CONSTRUCTION MONITORING REPORT

Eversource Transmission Lines:
F107

Alteration of Terrain Permit:
SEC Docket No. 2015-004

TYPE OF INSPECTION: Weekly Storm Event Incident Corrective Action

Fig 24: Filter sock around work pad for Str. 8. Viewing south. (12-14-19).

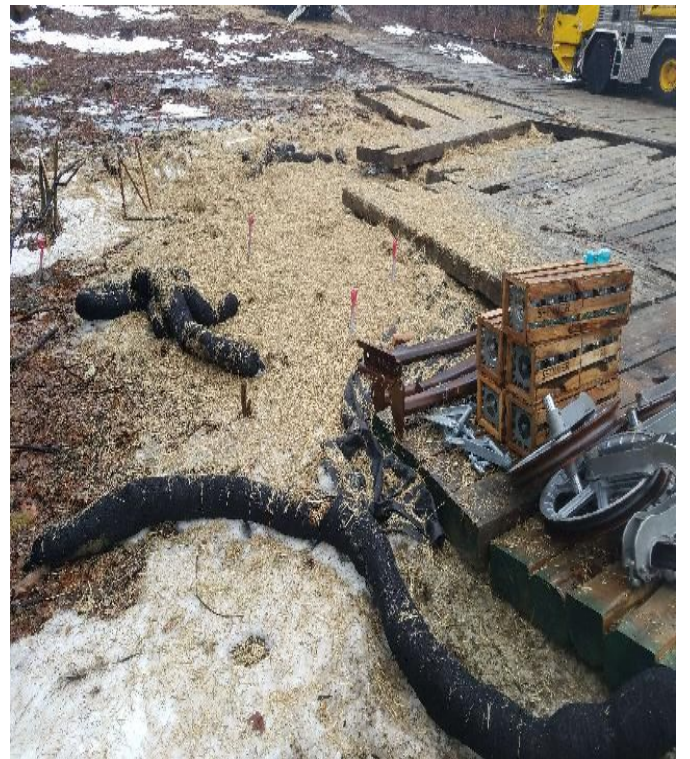
- Timber matted access roads are to be swept and maintained. See photo 22 below.
 - If BMPs are damaged during construction or line pulling they need to be replaced or repaired. See photo 24 below.
